**EL PASO WATER UTILITIES
PUBLIC SERVICE BOARD**

ADDENDUM NO. 2

**JOHN T. HICKERSON WRF
HEADWORKS BARSCREEN REPLACEMENT**

BID NO. 40-23

HEADWORKS
IMPROVEMENTS
SCOPE OF WORK

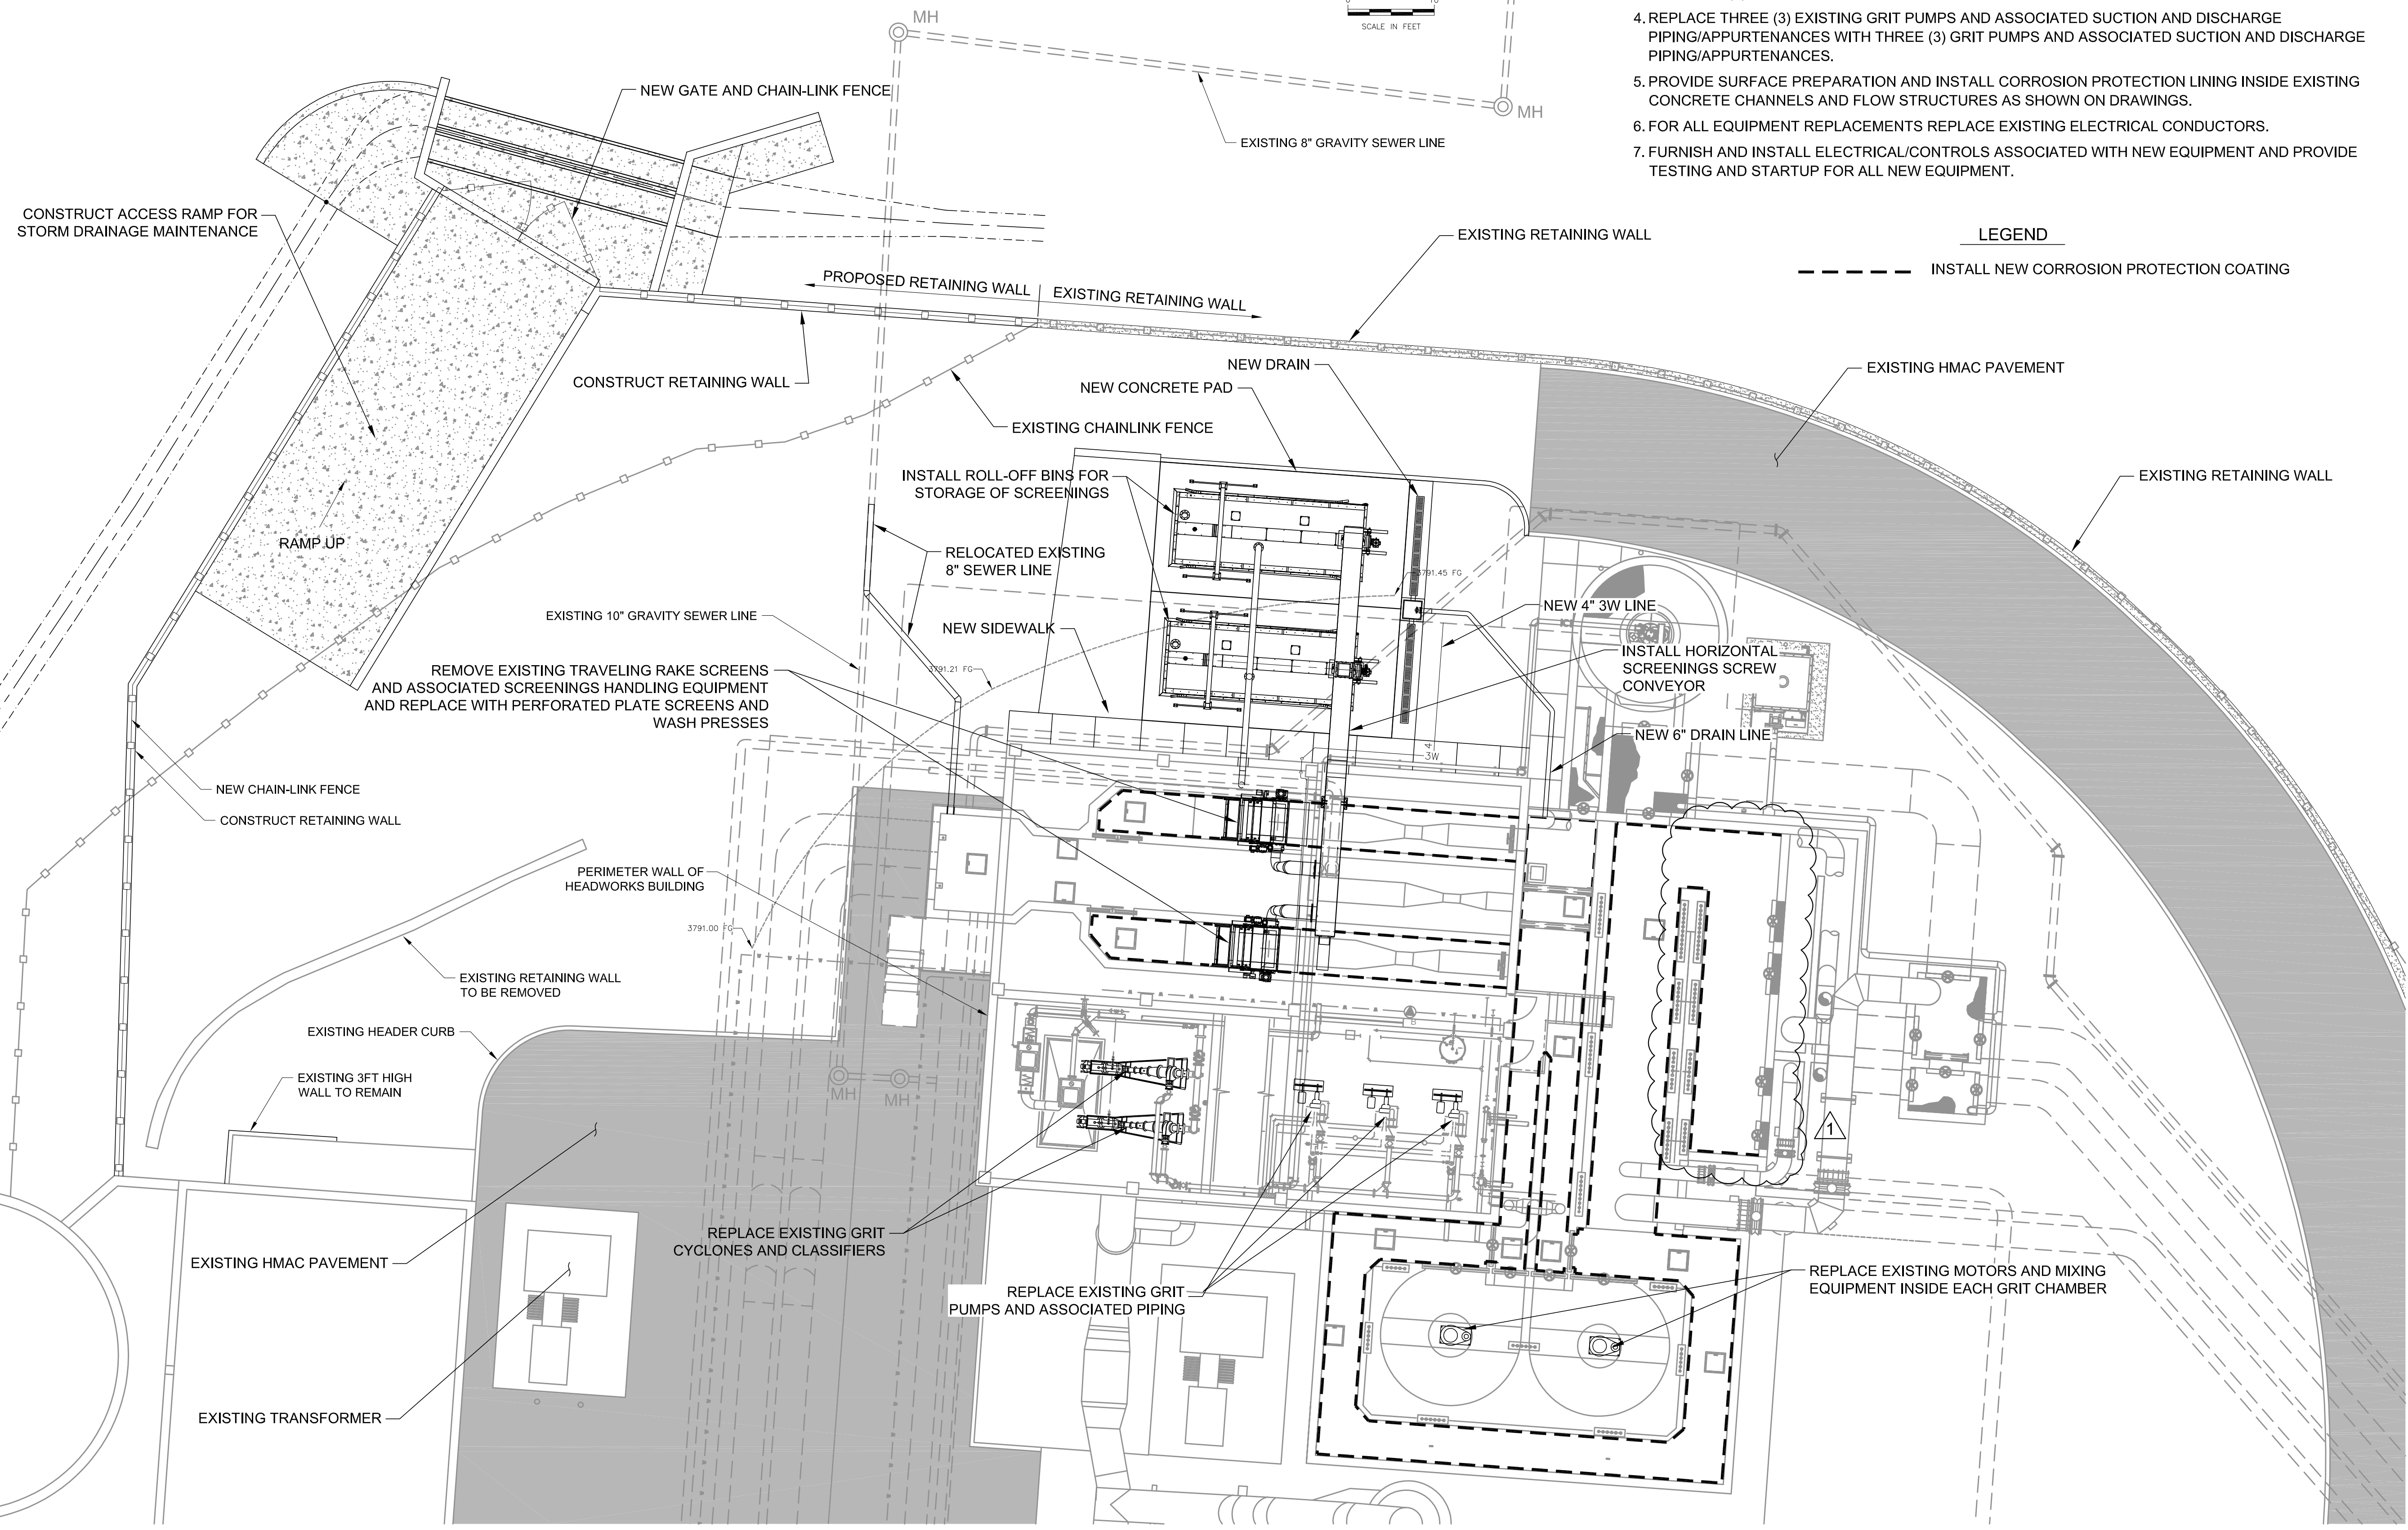
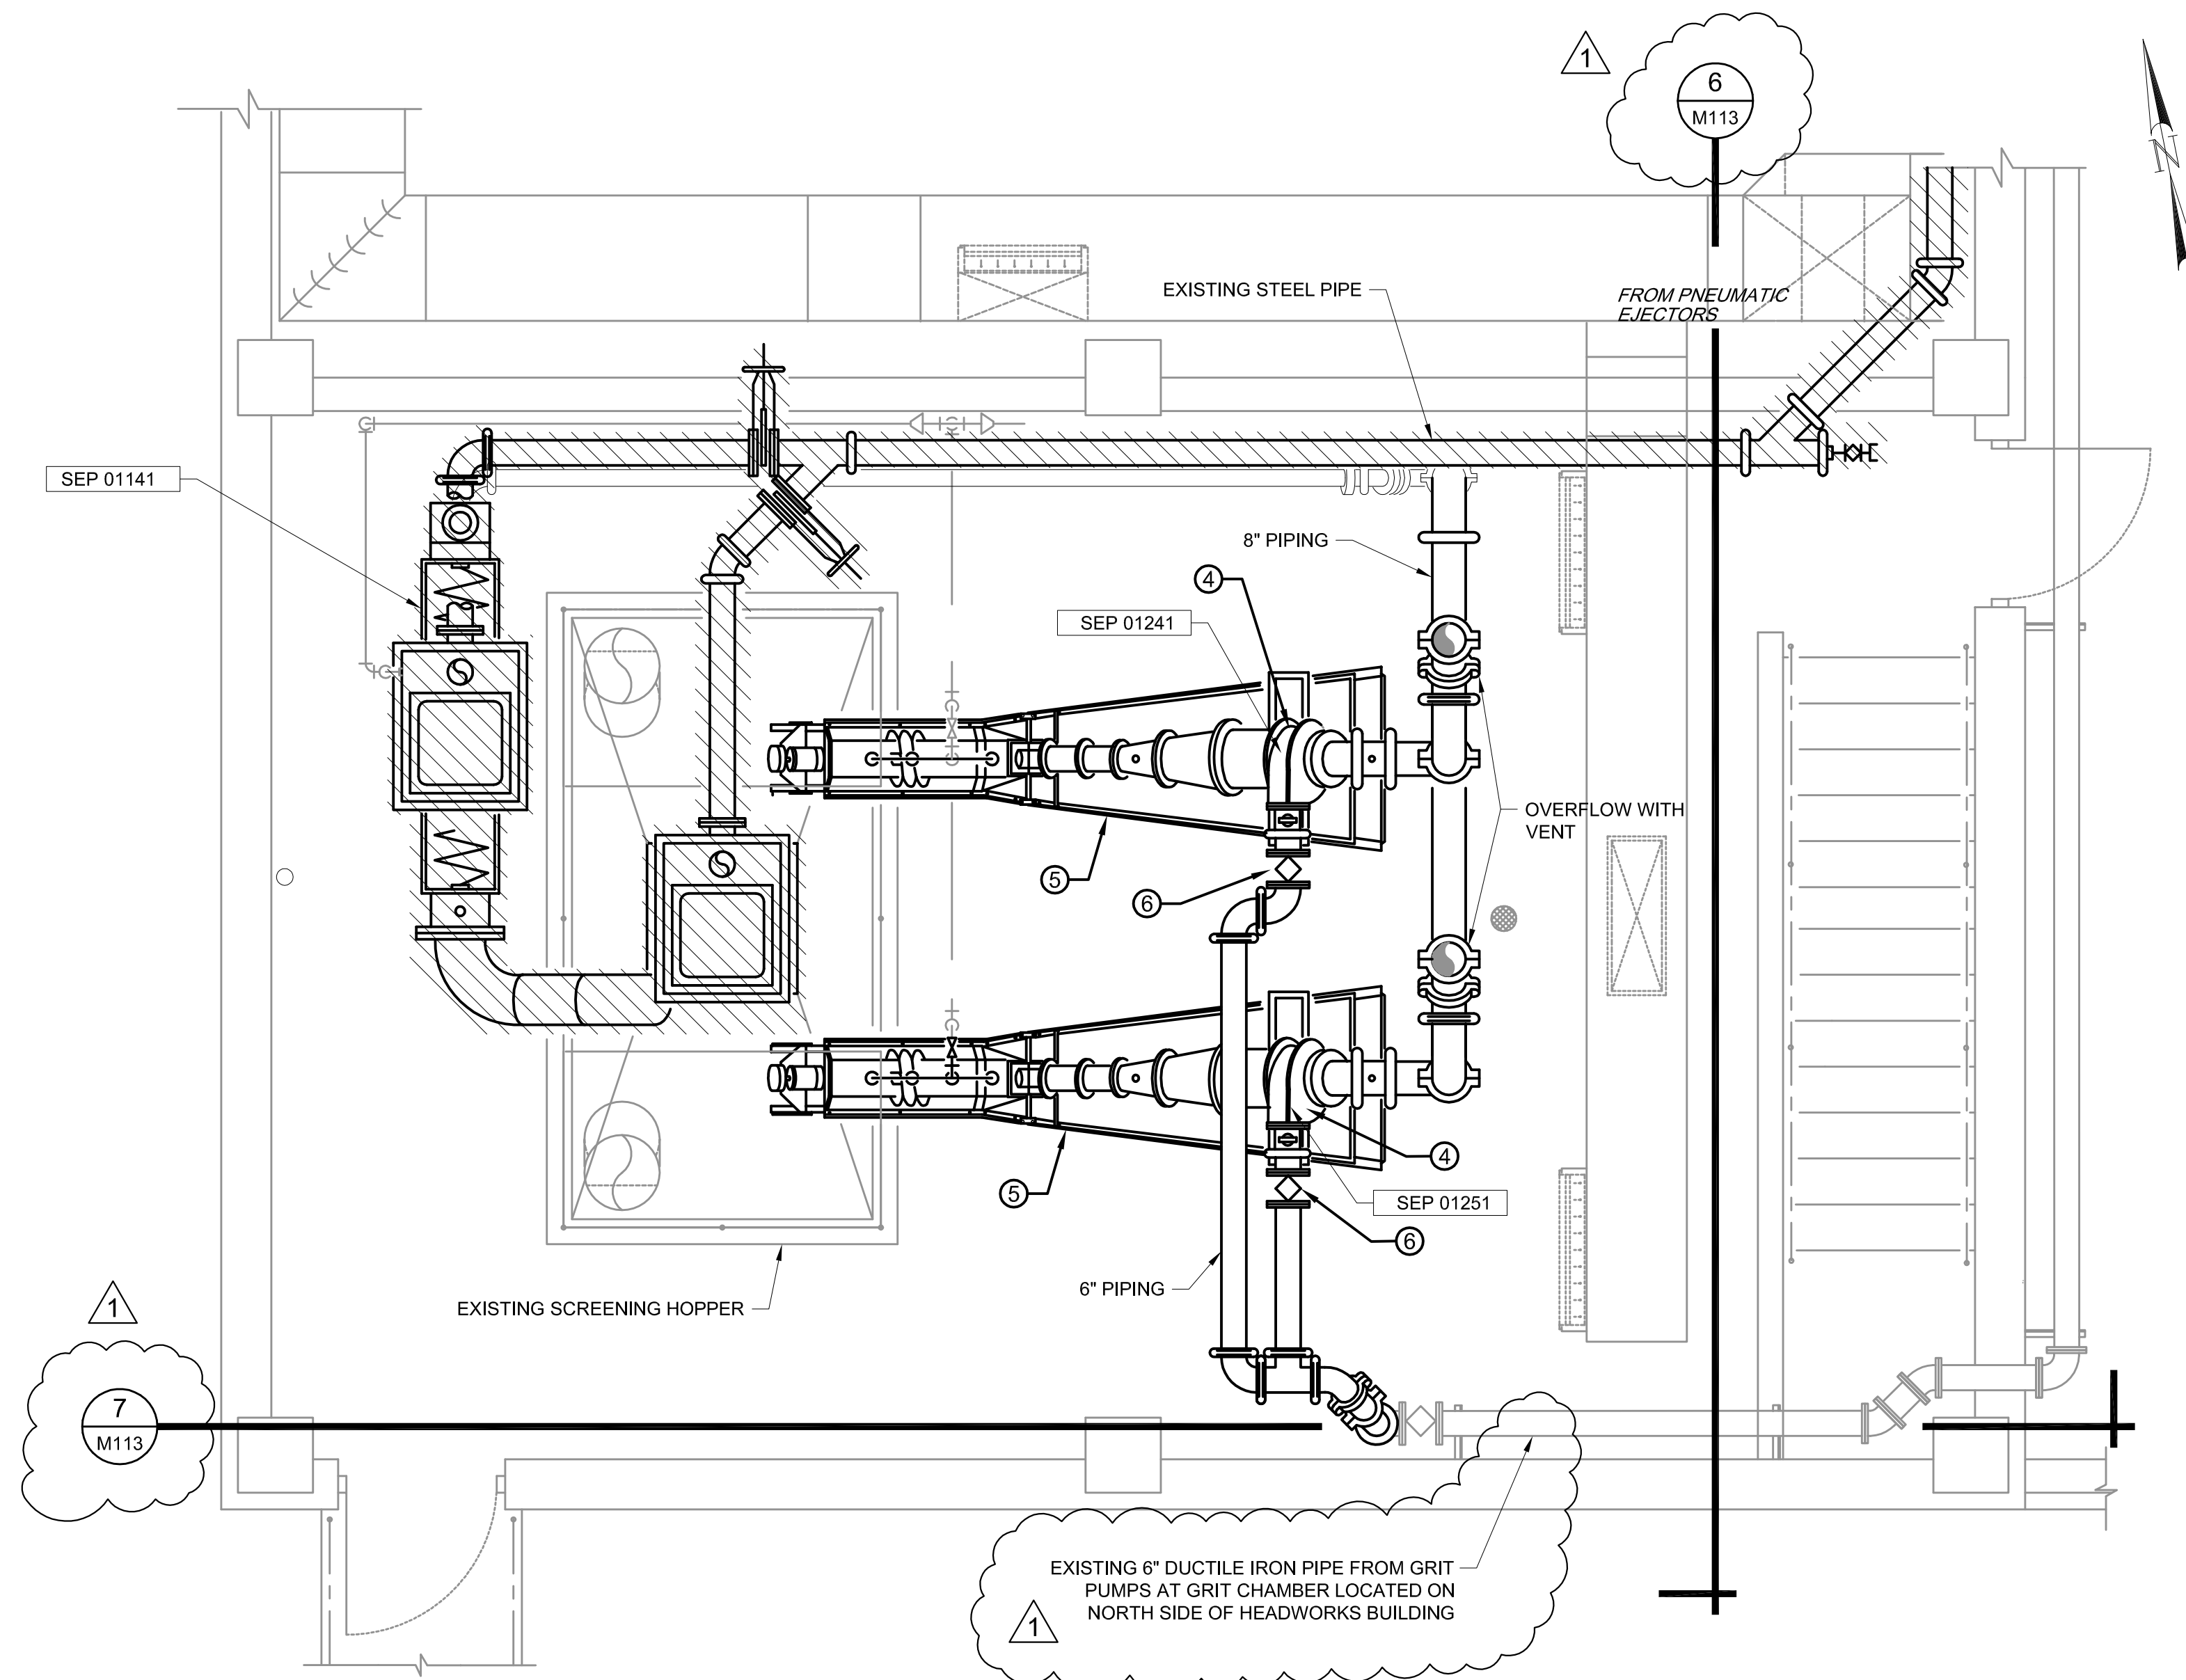
- A. REMOVE Sheet C101 in its entirety and REPLACE with revised Sheet C101 attached to this Addendum. The limits of protective coating have been increased from what was shown previously.

**MEZZANINE
PARTIAL PLAN
EQUIPMENT
REPLACEMENT AND
REMOVAL
M103**

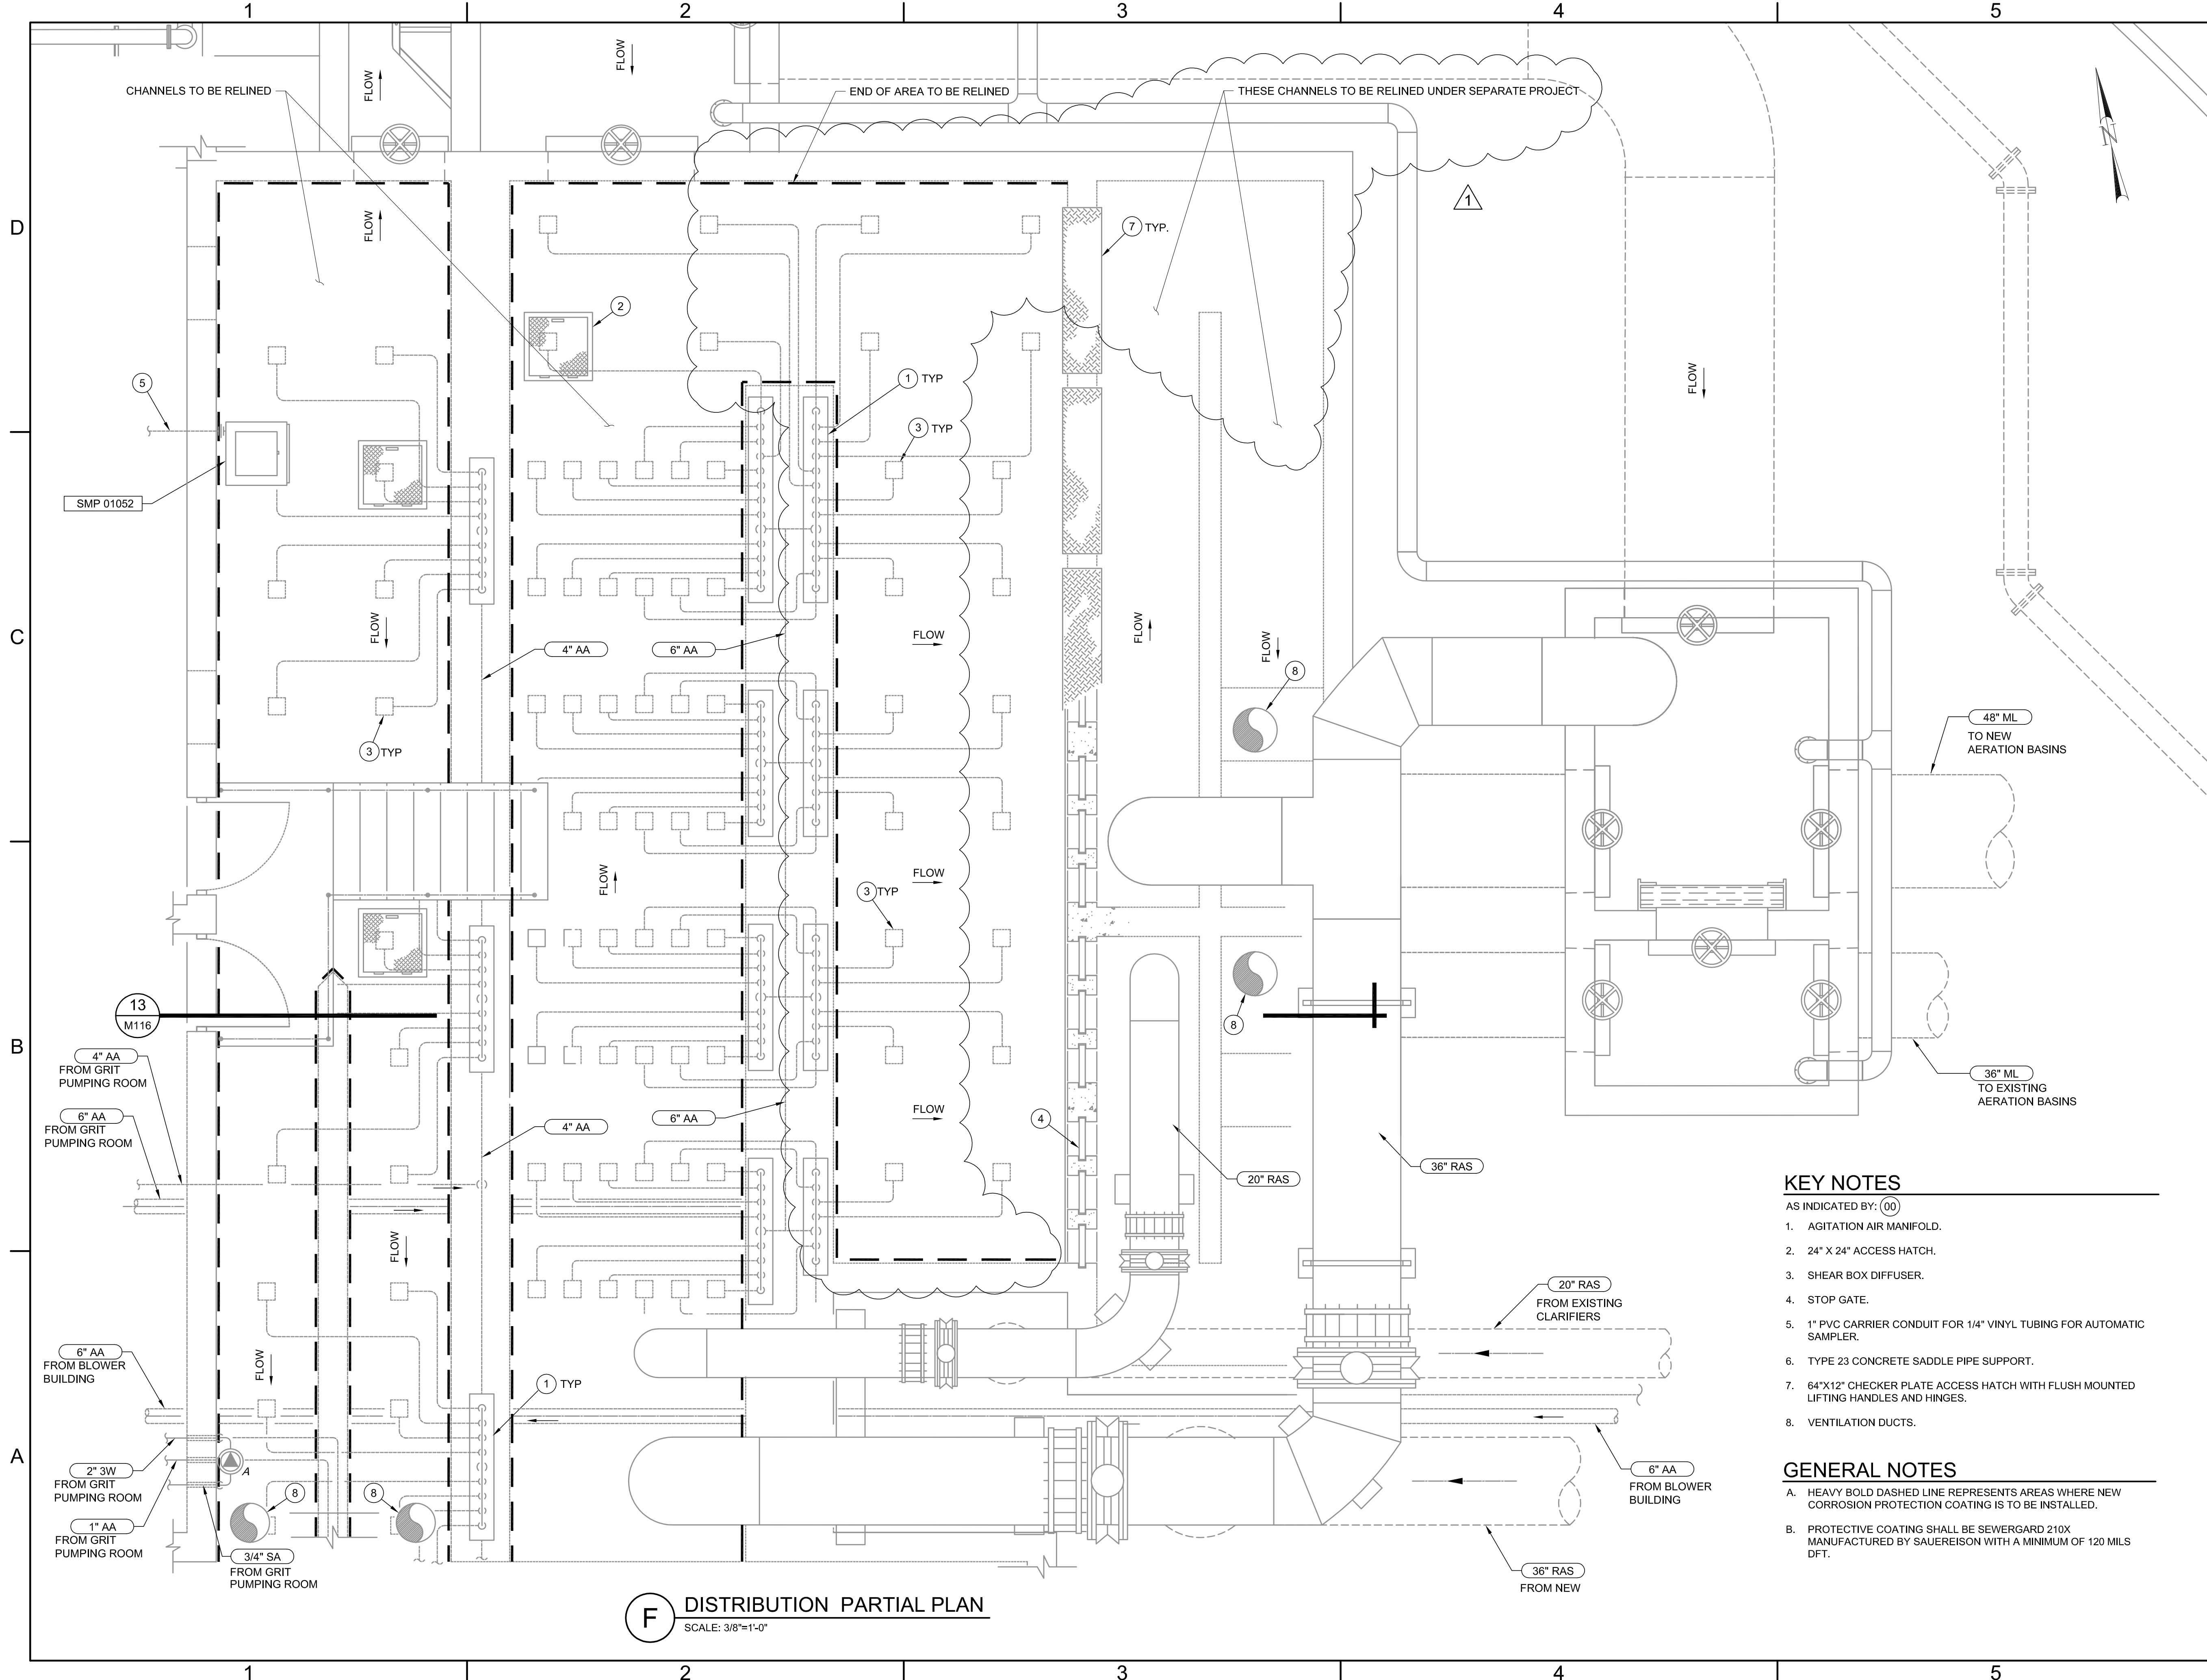
- A. REMOVE Sheet M103 in its entirety and REPLACE with revised Sheet M103 attached to this Addendum. The section reference number has been revised from what was shown previously. The size, material type, and function of existing grit pipe not being replaced is identified.
